ADDENDUM #1

TO: ALL PLAN HOLDERS AND POTENTIAL BIDDERS
FROM: TIFFANY McCANTS, PURCHASING OFFICER
SUBJECT: A.C. REYNOLDS MIDDLE SCHOOL RESTROOM REMODEL
(RFP# 26-19)

SUBJECT: AC Reynolds Middle School- Lower Level Restrooms – Addendum 1

4 DEMOLITION PLAN
1/4"=1'-0"

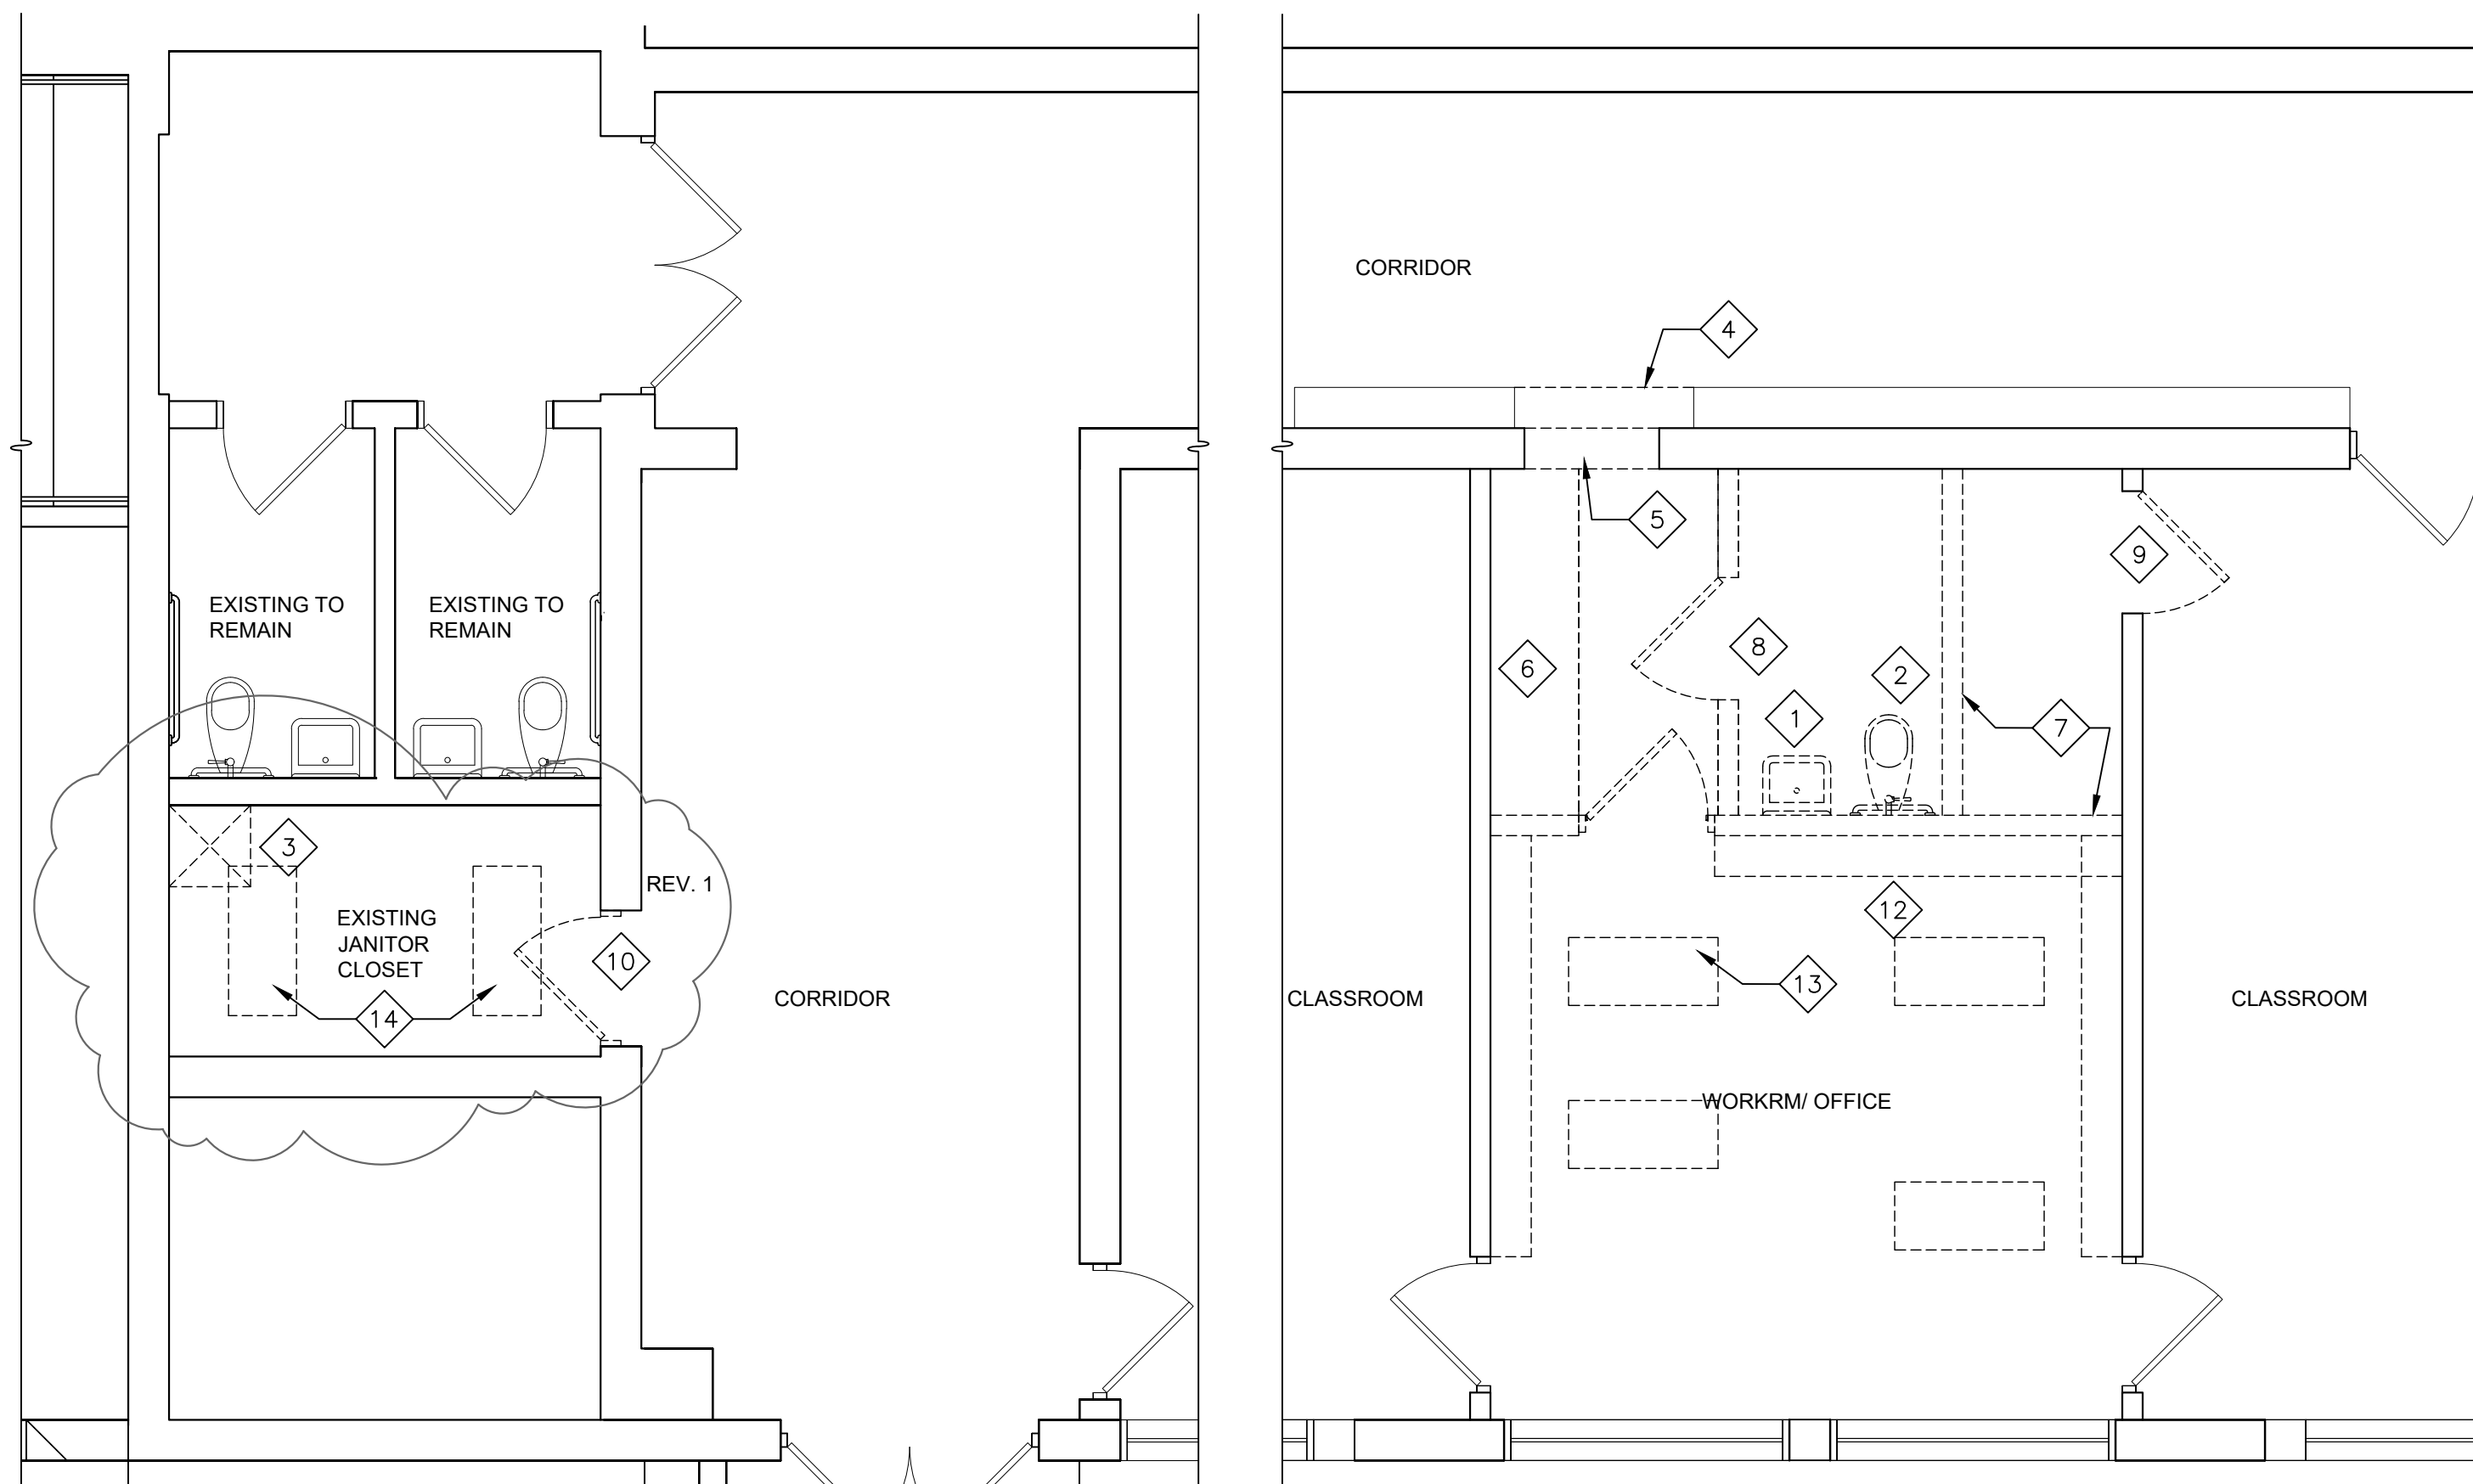
- 1 REMOVE LAVATORY & STORE FOR RE-USE
- 2 REMOVE WATER CLOSET & ELECTRONIC FLUSH VALVE STORE FOR RE-USE
- 3 REMOVE MOP SINK AND STORE FOR REUSE
- 4 REMOVE LOCKERS AS REQUIRED AND RE-INSTALL PER OWNER
- 5 INSTALL LINTEL AND REMOVE WALL PER 5/A1.1
- 6 REMOVE BUILT-INS AND MISC.
- 7 REMOVE EXISTING BLOCK WALLS AS SHOWN
- 8 REMOVE WALLS AND DOORS AS SHOWN
- 9 REMOVE DOOR AND FRAME
- 10 REMOVE DOOR AND FRAME
- 11 NOT USED. REV. 1
- 12 REMOVE EXISTING SHELVING.
- 13 REWORK EXISTING CEILING GRID AND RELOCATE LIGHT FIXTURES IN AREA OF NEW WALL. SEE ELECTRICAL DRAWINGS.
- 14 RELOCATE EXISTING LIGHT FIXTURES- SEE ELECATRICAL DRAWINGS. REV. 1
